## 4 Masterplan & Public Realm

# 6 Comparison Drawings

The following pages contain a series of comparison drawings to allow the amended design changes to be reviewed directly alongside the original approved planning drawings.

#### 6.3.1 North Elevation

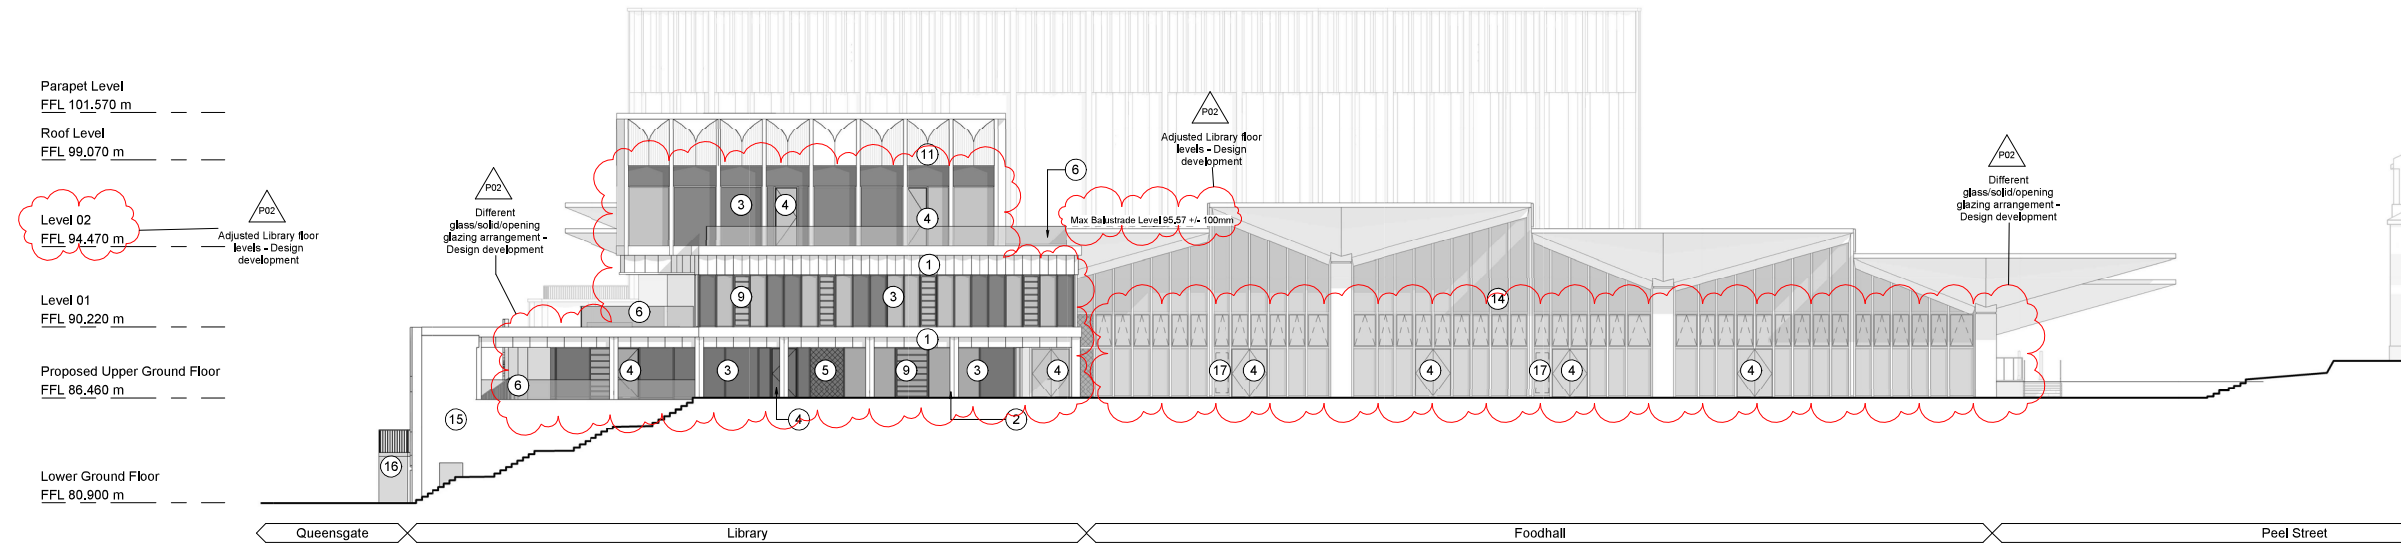
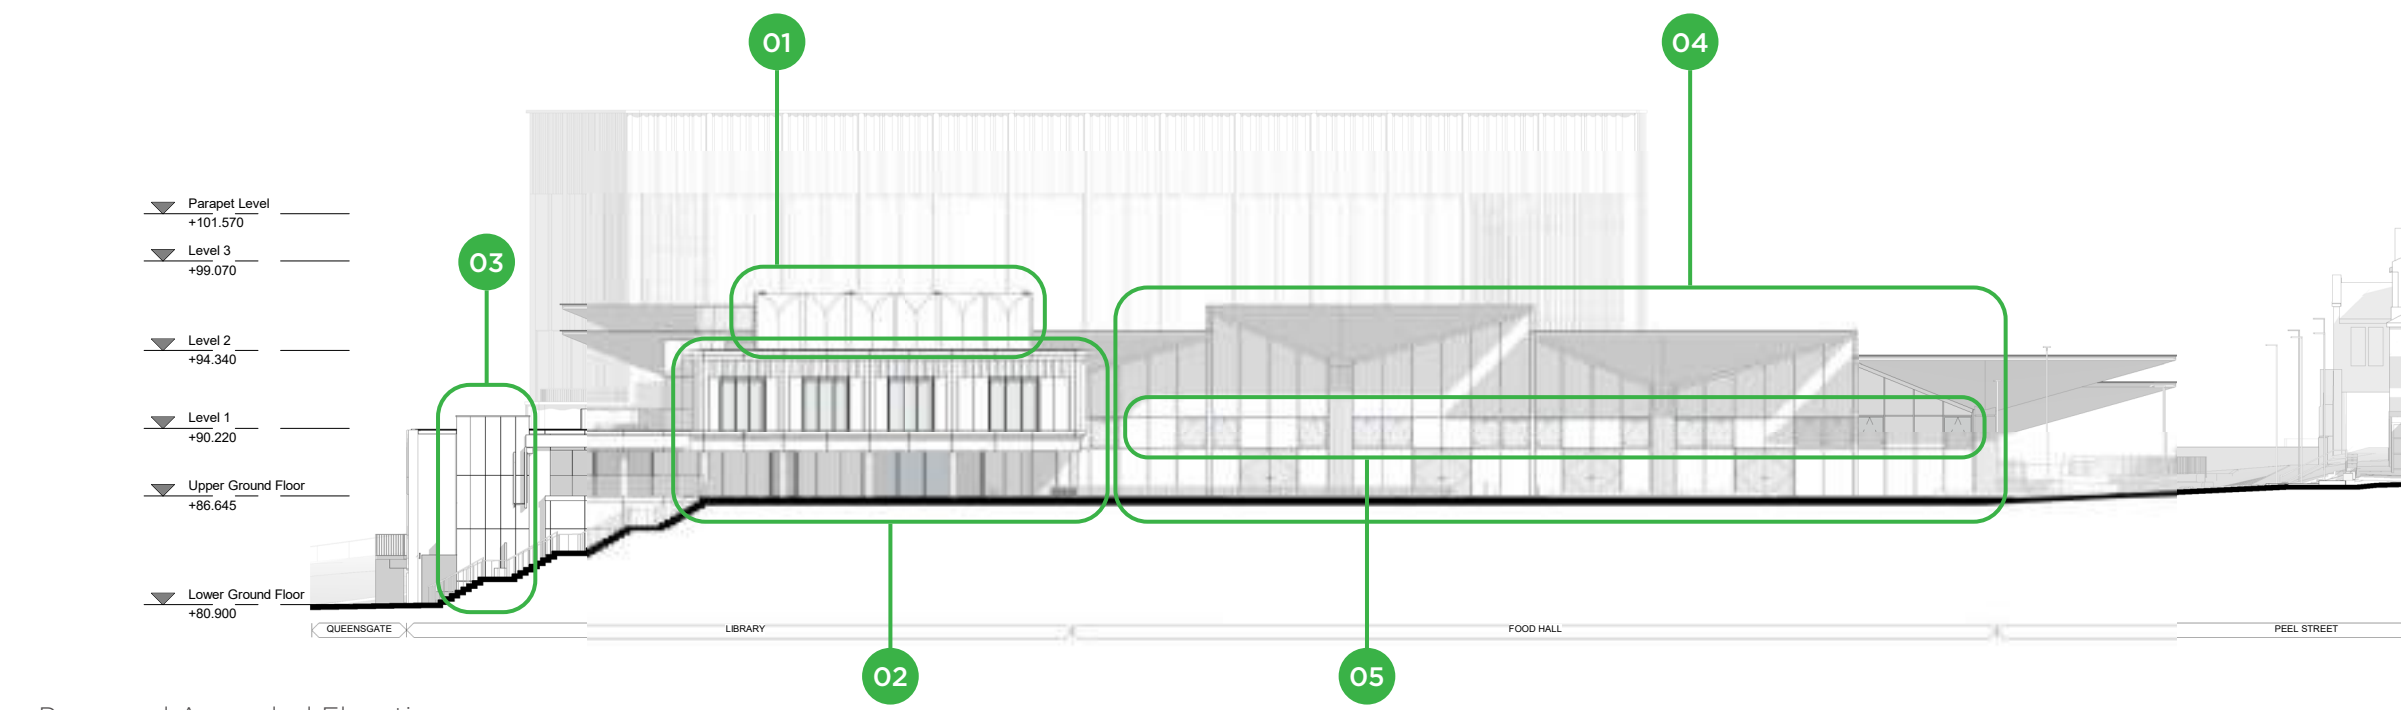
- 01 Omission of accommodation at second floor (event space and multi-purpose room) and relocation of plant enclosure down to this level.
- 02 Elevation bay treatment revised to address omission of event space.
- 03 Introduction of rainscreen cladding to lift enclosure due to relocation and to provide clear delineation between old/new elements
- 04 Increase in spacing of mullions glazing to suit changes to clerestory glazing.
- 05 No. of openable glazing panels reduced in line with natural ventilation requirements

#### 6.3.2 East Elevation

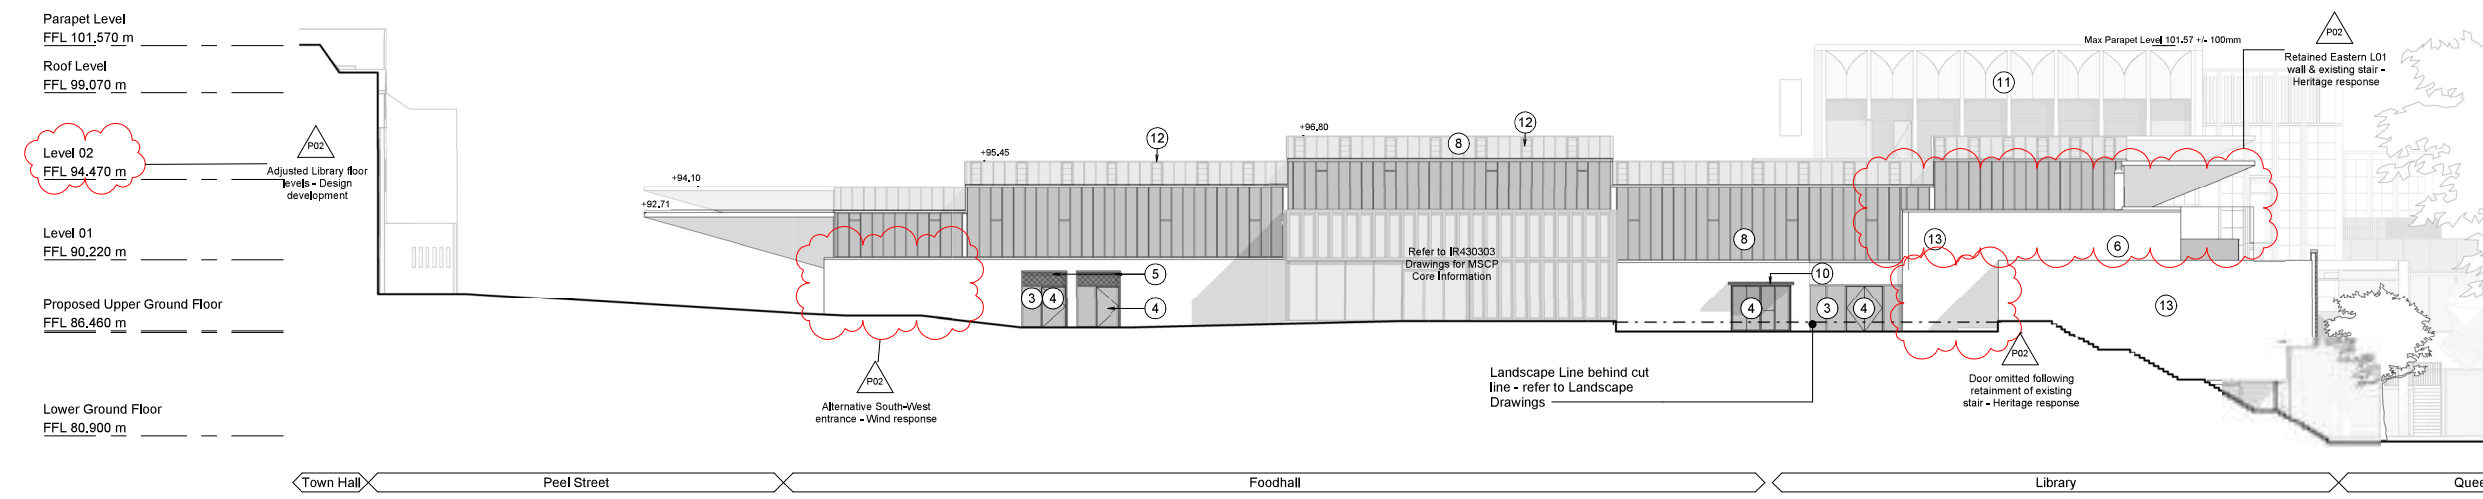
- 01 Omission of accommodation at second floor (event space and multi-purpose room) and relocation of plant enclosure down to this level.
- 02 Omission of glazed windows and doors to Queensgate.
- 03 Introduction of rainscreen cladding to lift enclosure due to relocation and to provide clear delineation between old/new elements

6.3.3 South Elevation

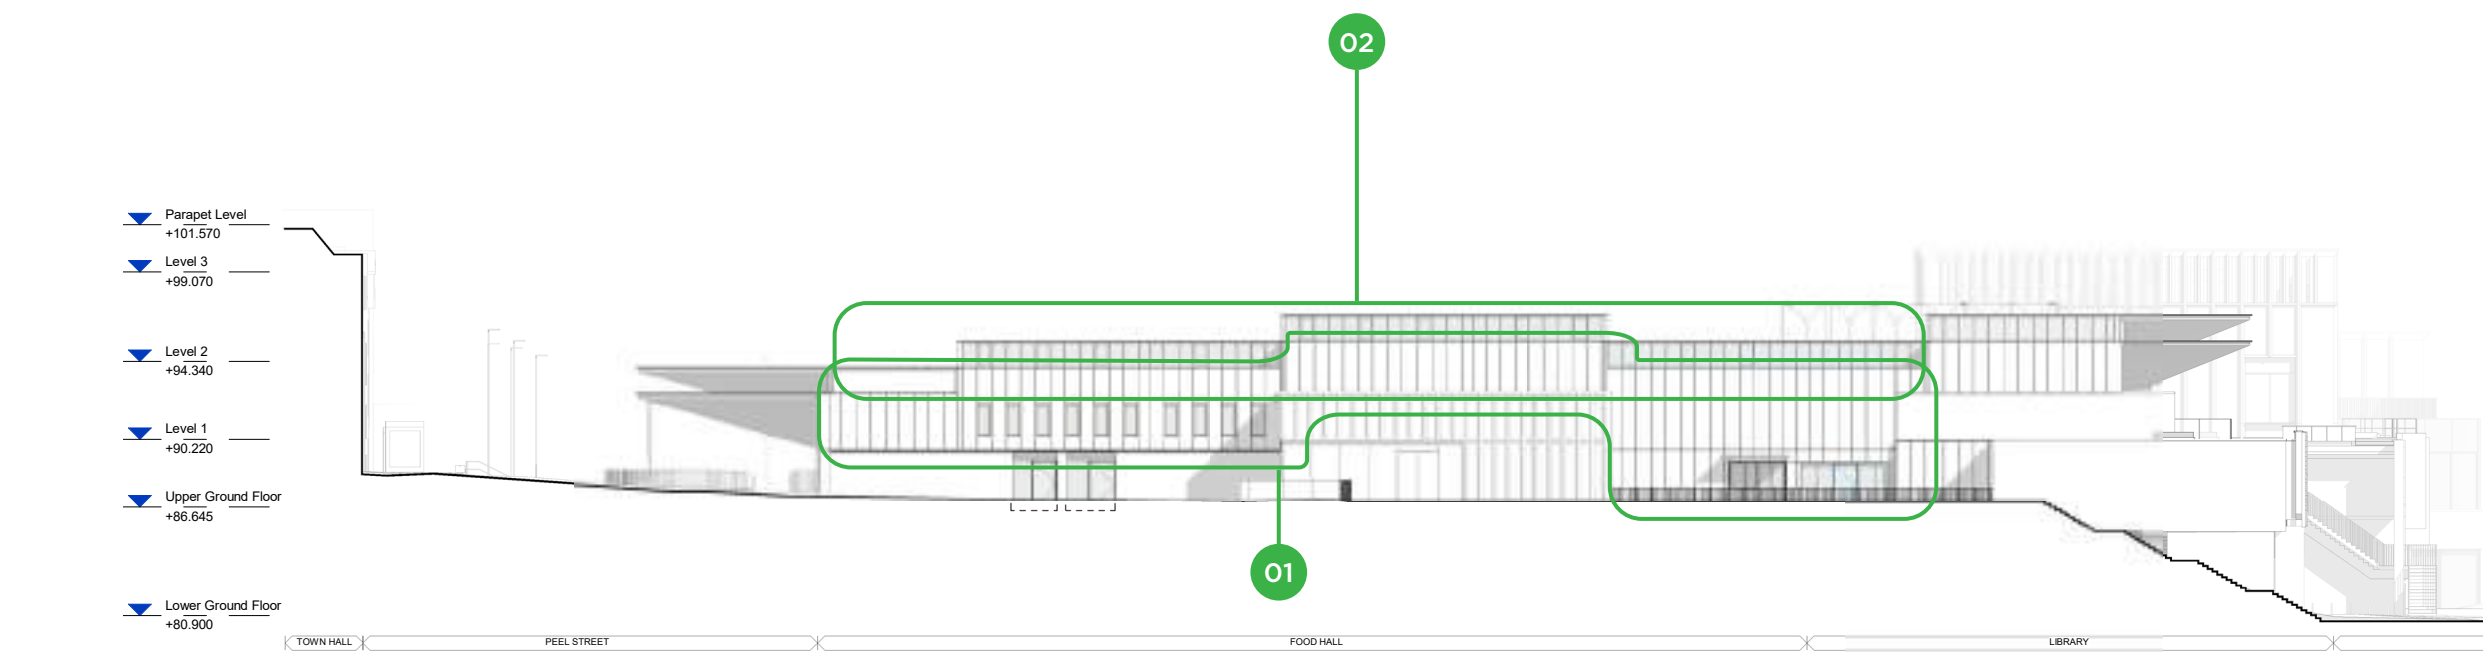
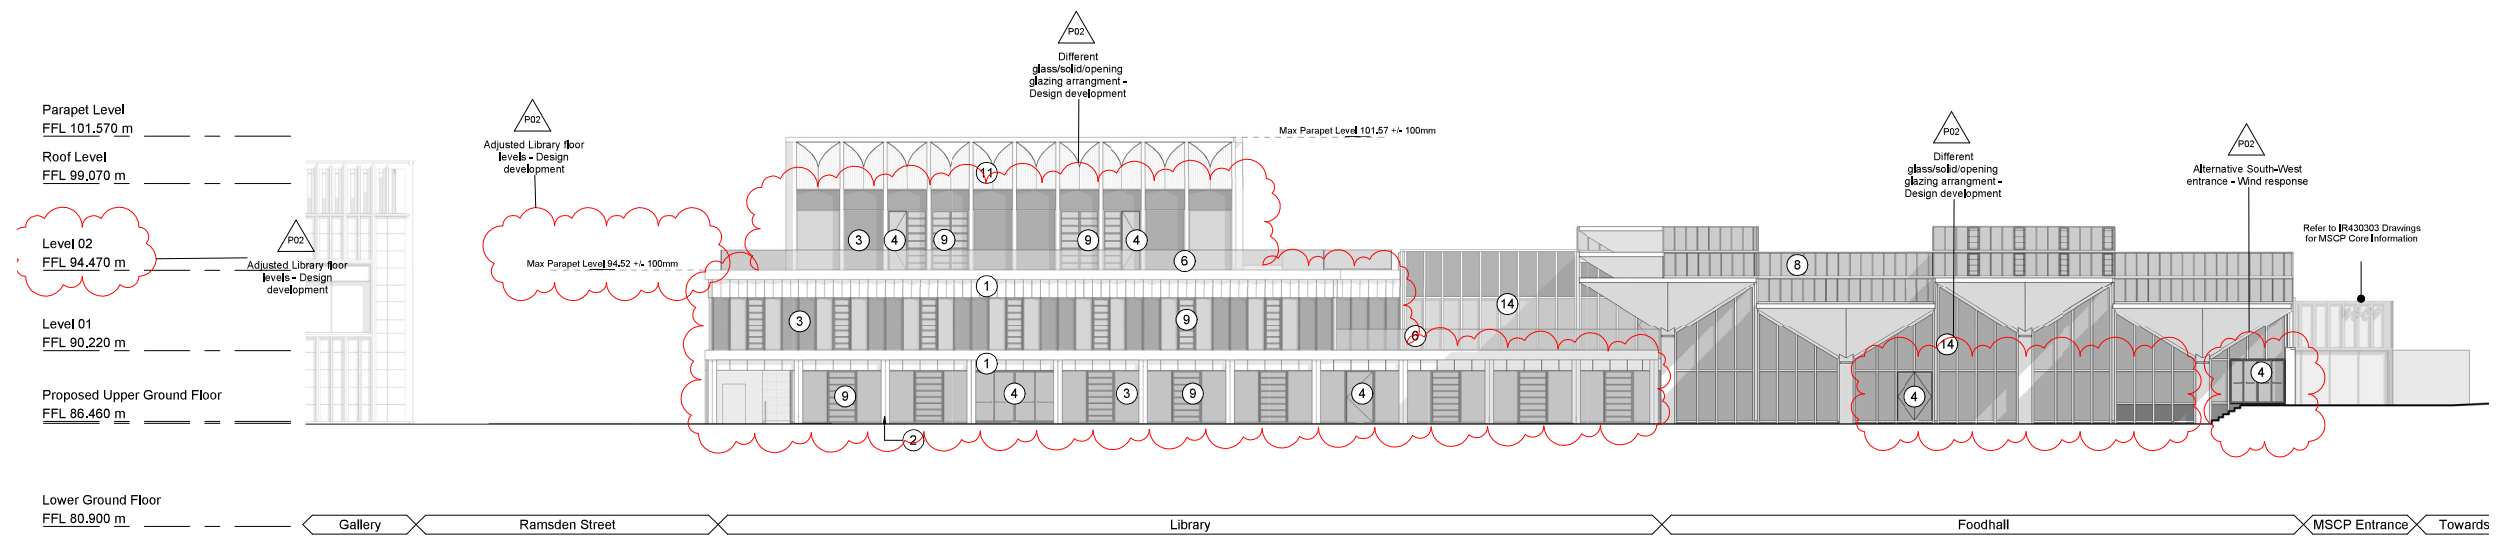
- 01 Omission of opaque glazing for solid metal cladding.
- 02 Increase in spacing of mullions on clerestory glazing.

6.3.4 West Elevation

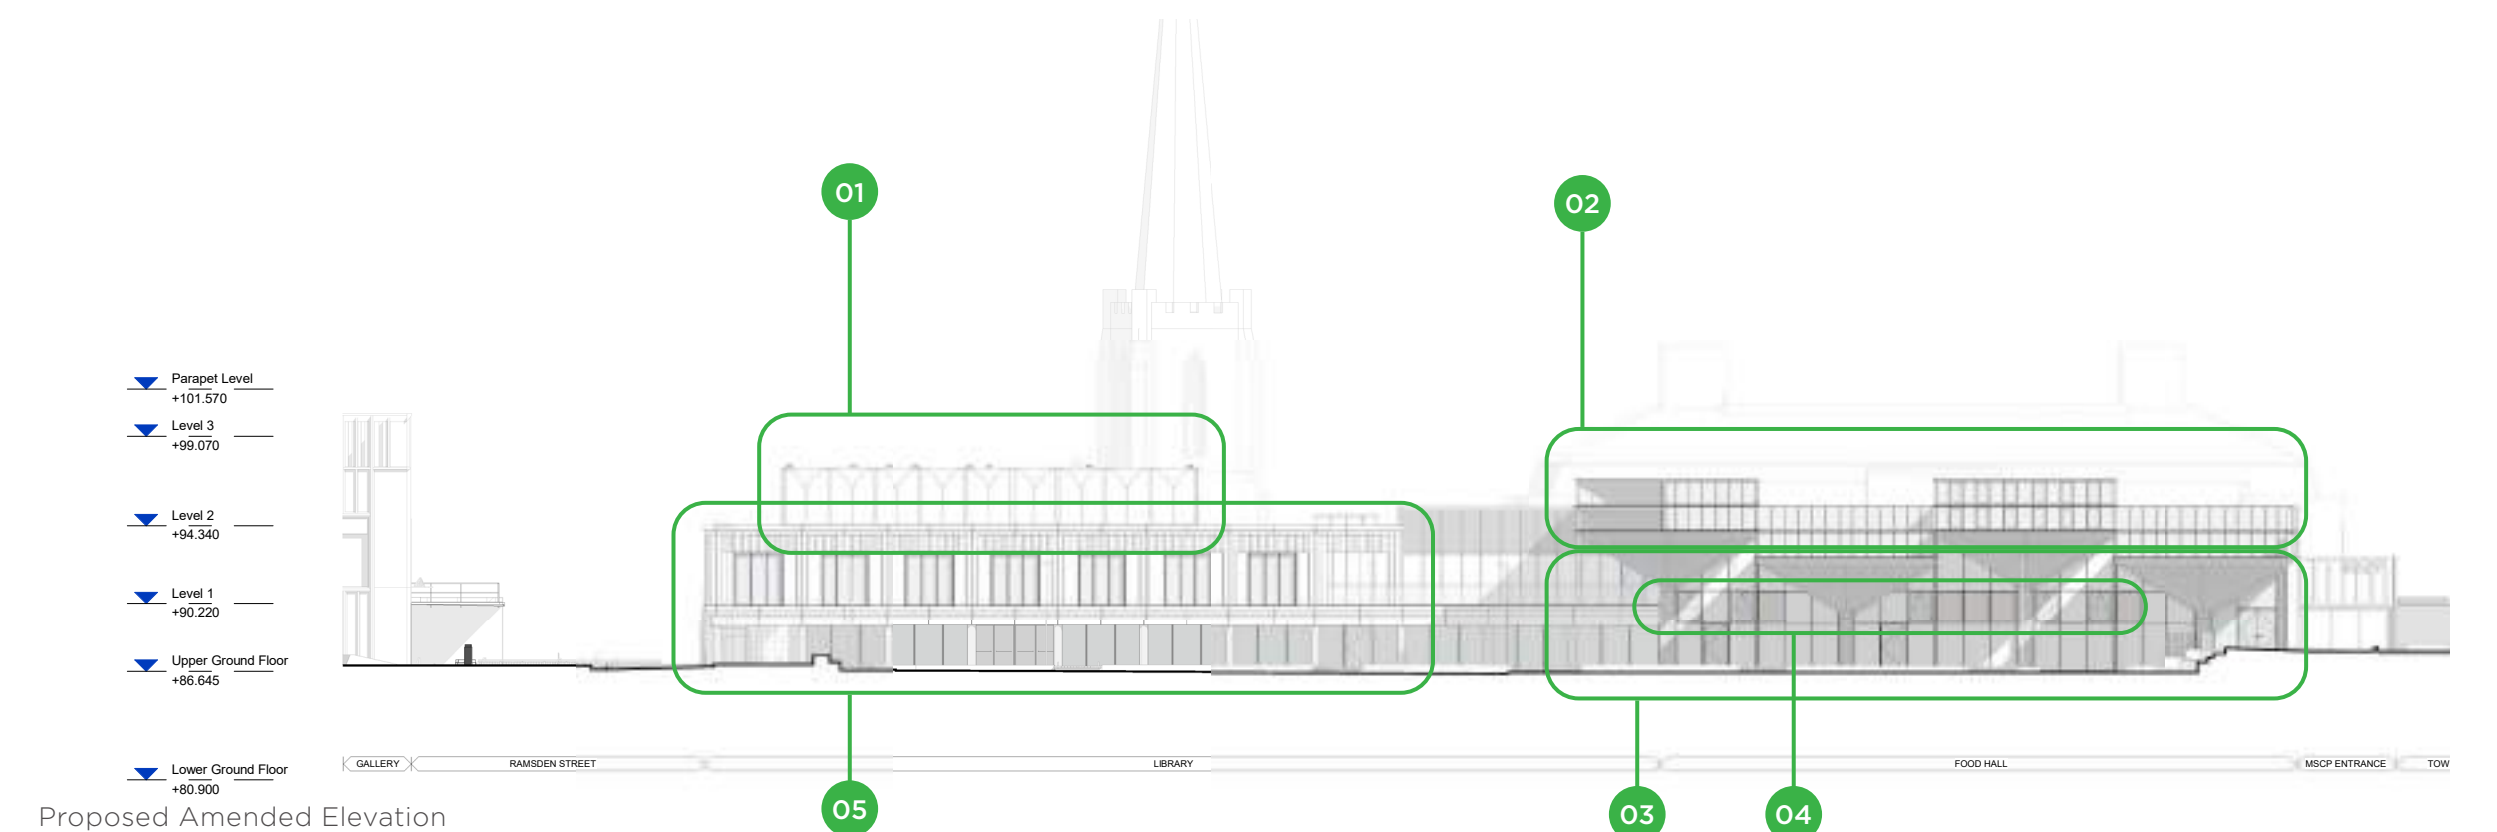
- 01 Omission of accommodation at second floor (event space and multi-purpose room) and relocation of plant enclosure down to this level.
- 02 Increase in spacing of mullions on clerestory glazing.
- 03 Introduction of solid cladding to west elevation of Food Hall.
- 04 Openable glazing panels introduced in line with natural ventilation requirements
- 05 Elevation bay treatment revised to address omission of event space.
